August 17, 2001

Donald C. Cook Nuclear Plant Units 1 and 2  
FINAL RESPONSE TO NUCLEAR REGULATORY COMMISSION  
REQUEST FOR ADDITIONAL INFORMATION  
REGARDING LICENSE AMENDMENT REQUEST FOR CONTROL ROOM  
HABITABILITY  
(TAC NOS. MA9394 AND MA9395)

FINAL RESPONSE TO NUCLEAR REGULATORY COMMISSION  
REQUEST FOR ADDITIONAL INFORMATION  
REGARDING PROPOSED CONTROL ROOM HABITABILITY LICENSE AMENDMENT

FIG.1. PARTITION OF IODINE BETWEEN GAS PHASE AND WATER AT 25°C

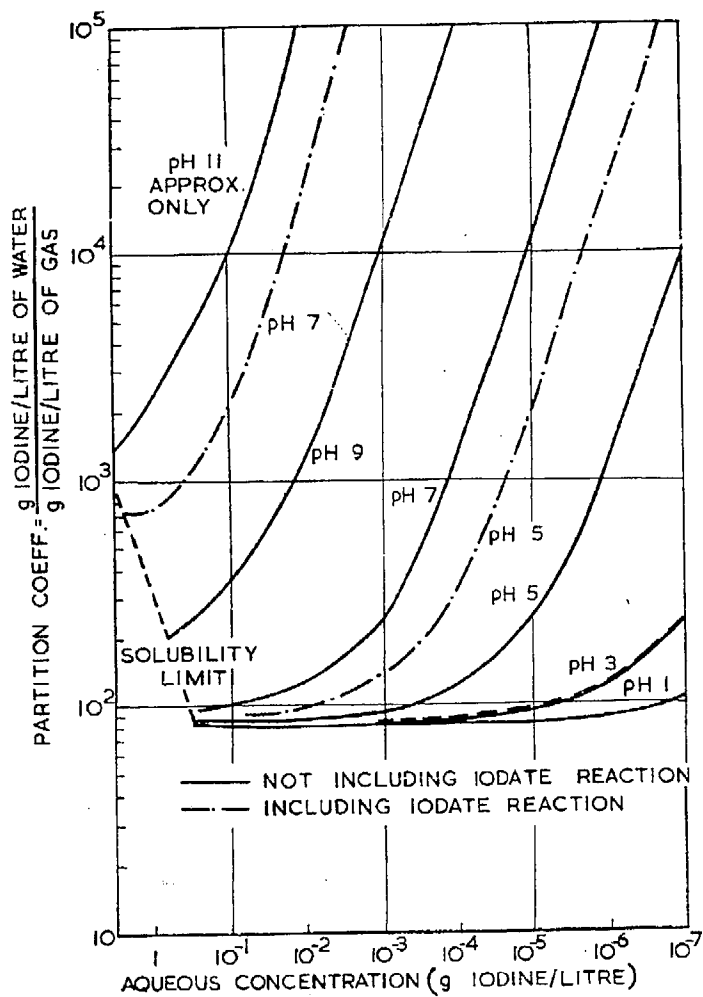
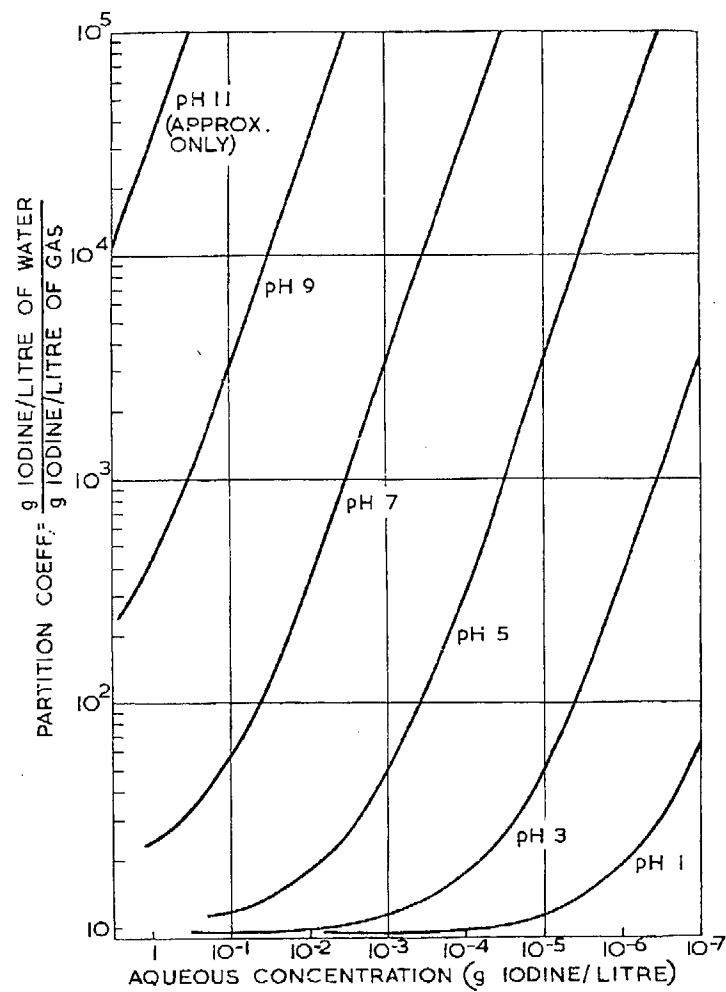
*Your analyses incorporated an iodine flashing fraction of  $10^{-4}$  for emergency core cooling system (ECCS) leakage, contrary to the default  $10^{-1}$  assumption provided in RG 1.183. On Pages 5 and 6 of Attachment 1 to your submittal, you attempted to justify these assumptions on an experiment reported in your existing UFSAR, and on theoretical iodine partitioning of  $10^{-8}$ . The staff does not believe that the provided justification supports the use of  $10^{-4}$  for the ECCS flash fraction. Based on the description of the experiment, the staff questions whether the experimental drying to evaporation can appropriately model leakage that could be sprayed from the leakage paths, or as droplets fall through air and impinge on nearby surfaces. The staff also questions how well Eggleton's mathematical treatment of steady state vapor partial pressures between the gas and liquid phases can adequately model the more dynamic situation associated with leakage from pressurized systems as is the case here. Your submittal quoted partitioning of  $10^{-8}$  which appears to be at odds with the abstract for Eggleton work which reports partitioning values ranging from 0.012 at high iodine concentrations and low pH to less than 0.0001 at high pH and low iodine concentrations. Please provide additional justification, including consideration of sump pH and area ventilation rates and iodine entrainment in evaporated vapor, in support of your assumption.*

The Eggleton study determined equilibrium iodine partition coefficients, (i.e., g-iodine per liter water / g-iodine per liter gas) as a function of temperature, iodine concentration in the water, pH value, and whether an iodate reaction can be credited. The effect of these variables and the values that apply to CNP are described below

Temperature – More iodine would be released to the atmosphere at lower solution temperatures. The Eggleton report provided two graphs showing the partition coefficient based on the variables involved. One graph presented the partition coefficient for a solution temperature of 25°C and another graph presented the partition coefficient for a solution temperature of 100°C. The graphs are reproduced below. The post-LOCA containment sump water temperature is expected to be between 139°F and 190°F. This corresponds to 59°C to 88°C. Therefore, use of the graph for a 25°C solution is conservative.

Iodine Concentration - More iodine would be released to the atmosphere at higher sump iodine concentrations. Using the total core iodine activities and the decay constants from Tables 4 and 6 of Attachment 6 to Reference 1, the total core inventory would be approximately 1080 grams of iodine. As indicated in Table 2 of RG 1.183, an early in-vessel release would result in 35% of the iodine being released from the core. Assuming all of this 35% was in the sump, the sump would contain approximately 380 grams of iodine. As indicated by item L25 of the design information transmittal (DIT), DIT-B-00069-06, that was included with Attachment 6 to Reference 1, the minimum sump inventory at switchover to the sump recirculation phase would be 216,000 gallons, or conservatively, approximately 817,000 liters. Therefore the maximum sump iodine concentration would be approximately 0.0005 grams-iodine/liter. As indicated by item L24 of DIT-B-00069-06, the minimum sump inventory after all ice is melted would be 514,642 gallons. Consequently, the long term steady state iodine concentration would be less than half the 0.0005 grams-iodine/liter value. Therefore, use of a sump iodine concentration of 0.0005 grams-iodine/liter ( $5 \times 10^{-4}$  grams-iodine/liter) with the Eggleton graph is conservative.

### SGTR MASS RELEASE COMPARISON

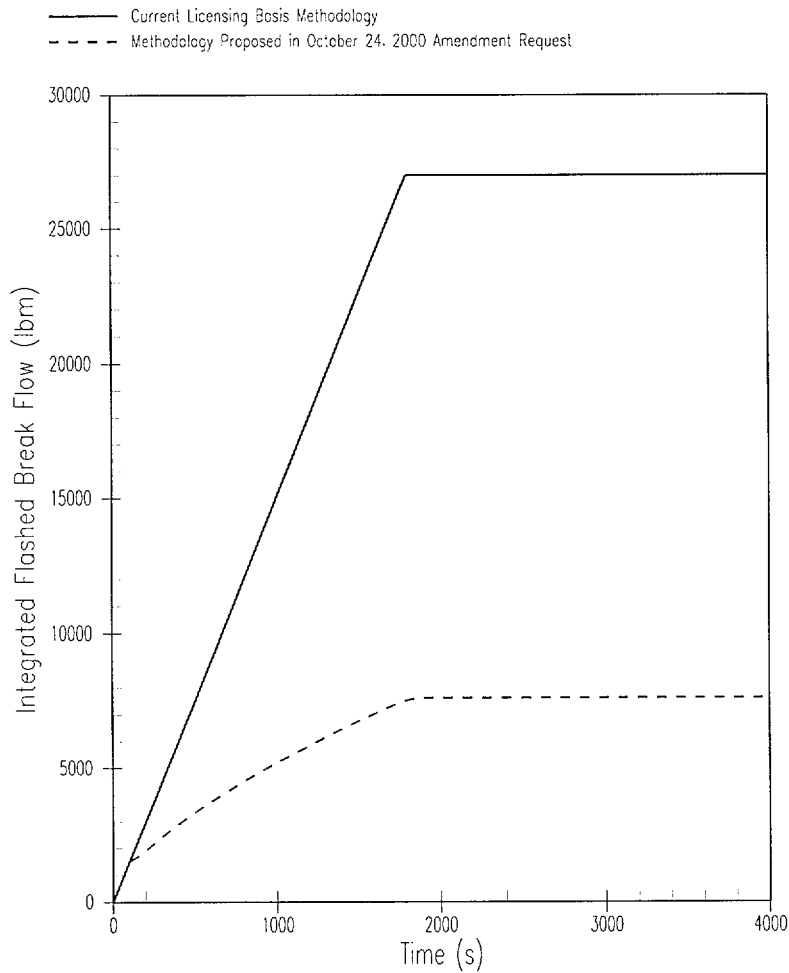
*On Page 7 of Attachment 1, you note your conclusion that the assumption of a constant break flow for 30 minutes is more limiting than using the actual operator response times. Although this assumption may be valid with regard to mass of reactor coolant system (RCS) transferred to the secondary, what is the sensitivity of other analysis parameters to delays in operator actions, such as break flow flashing fraction, steam release from the affected steam generator, and tube uncover? The staff is concerned that these other parameters, and the time-dependent buildup of RCS activity due to iodine spiking, could negate the apparent conservatism in the RCS mass transferred. Please confirm your conclusion relative to the postulated dose to the control room operators. Please explain how your amendment request dated October 24, 2000, on steam generator tube rupture (SGTR) analysis methodology affects this control room amendment request.*

The differences in the mass release values determined by the two methodologies are discussed below with respect to their effect on the calculated doses resulting from iodine and noble gasses.

In the above table, the Integrated Flashed Break Flow is the portion of the integrated break flow that flashes to steam. The values given in the above table are graphically illustrated in the following figure.

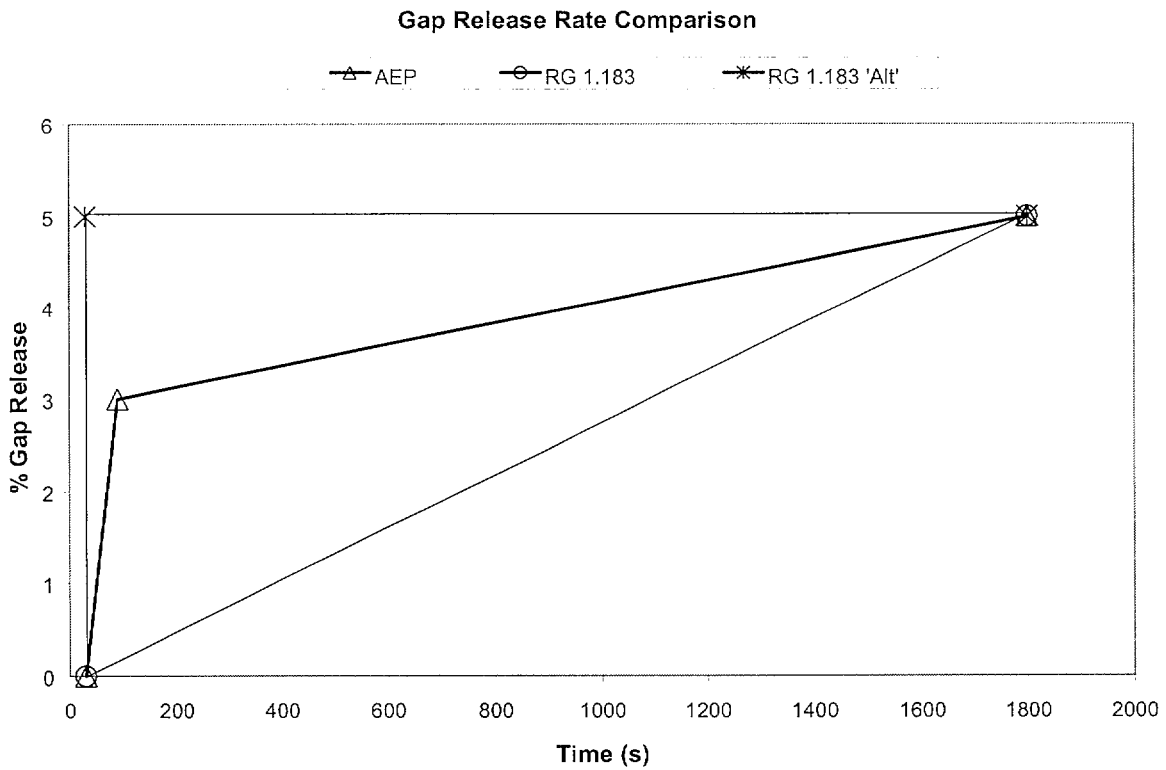
*§3.1.1 of Attachment 6, identifies the assumption that 3 percent of the gap activity is released from 30 seconds to 90 seconds and the remaining 2 percent of the gap is released over the next 28.5 minutes. RG 1.183 (and DG-1081) provided that the activity would be released from the core in a linear fashion over the duration of the release phase, or as an alternative, released instantaneously at the start of the particular release phase. Please provide a justification for this proposed alternative from RG 1.183.*

Section 3.0 of Attachment 6 to Reference 1 provides the proposed analysis of a small break LOCA. The gap release timing assumption used in the proposed analysis and the assumption options identified in RG 1.183 are graphed in the figure below. The assumption used in the proposed analysis, an essentially instantaneous release of 3% of the core activity combined with a subsequent linear release of 2% of the core activity, is enveloped by the two simpler alternatives identified in RG 1.183. Therefore, the assumption option chosen had no significant impact on the radiological consequences determined for the event.

Additionally, if it is assumed that either the instantaneous release model or the linear release model would provide more conservative results, the combined release model approach used in the proposed analysis ensured that at least a portion of the gap release was modeled using the more conservative modeling. If the two release models defined in RG 1.183 are considered as equivalent, a combination of the two models would also be equivalent, provided that the model includes release of the defined gap inventory to the containment in the half hour period specified.

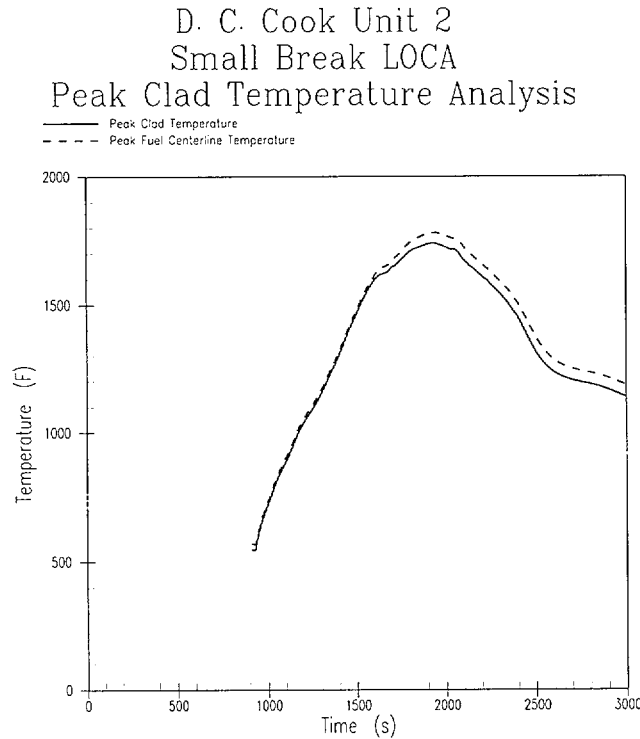
*Please provide a description of the SBLOCA T/H analysis that was performed for determining the source term. Please include a summary of and justification for the initial assumptions used, the sequence of events, the criteria used for determining fuel pin failures and/or fuel melting, the technical basis supporting the decision criteria, and the results of the analysis from the standpoint of justifying the analysis as limiting with respect to source term.*

2200°F specified in the regulation. Since control rod insertion would terminate core power generation, the fuel pellet temperature would not be significantly higher than the cladding temperature. This is illustrated by the figure below.

This figure shows the base transient calculation of PCT for CNP Unit 2, together with the calculated peak fuel centerline temperature. Since the fuel pellet temperature would not be significantly higher than the cladding temperature, the cladding temperature would be maintained below 2200°F, and the fuel would not exceed its melting temperature of 4700°F
